PLC-5/VME VMEbus Programmable Controllers

(Cat. No. 1785-V30B, -V40B, -V40L, and -V80B)

Introduction

These release notes supersede publication 1785-6.5.9-RN1, May 1995.

Using VME Interrupts

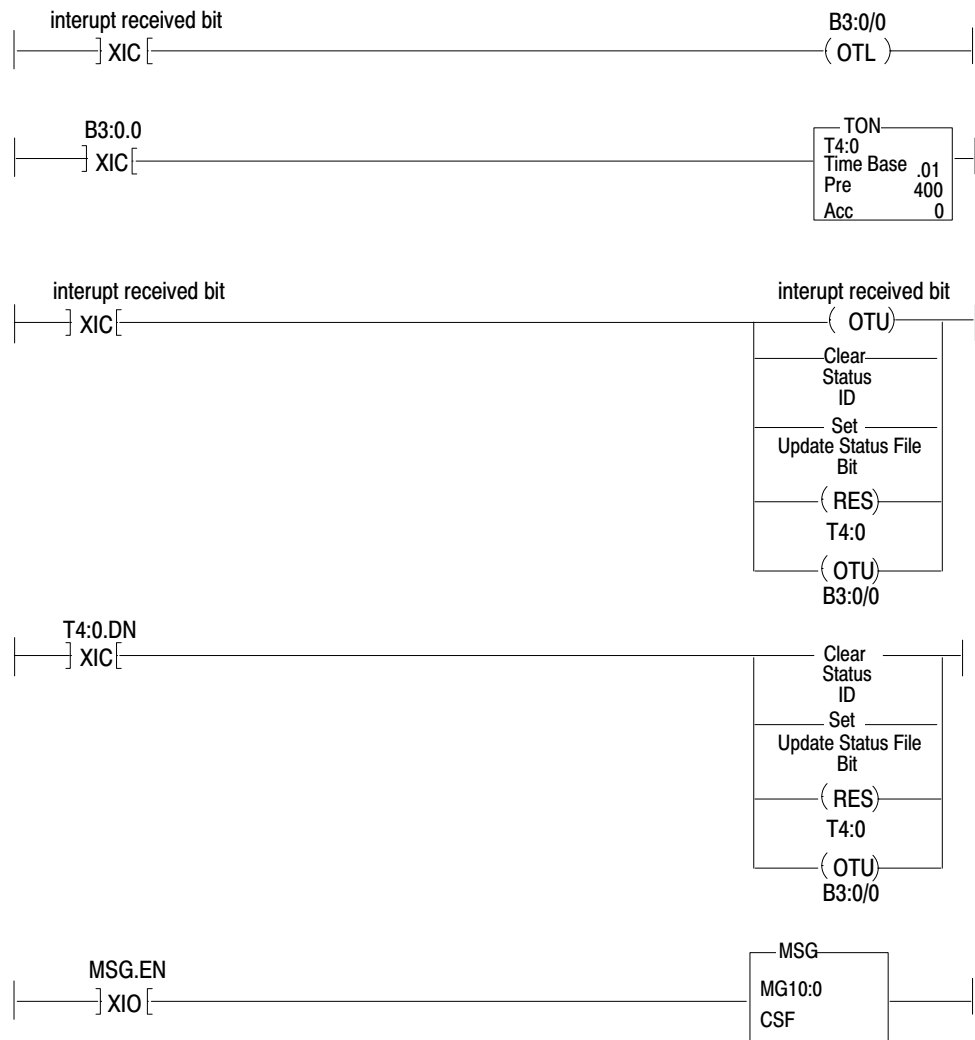
If you:

- set the NOCV bit to 1
AND
- use the VME interrupt receive bits in the VME status file

then you should implement ladder logic similar to the following example to avoid missing interrupts:

You may need to tune the value of the TON timer for each unique application.
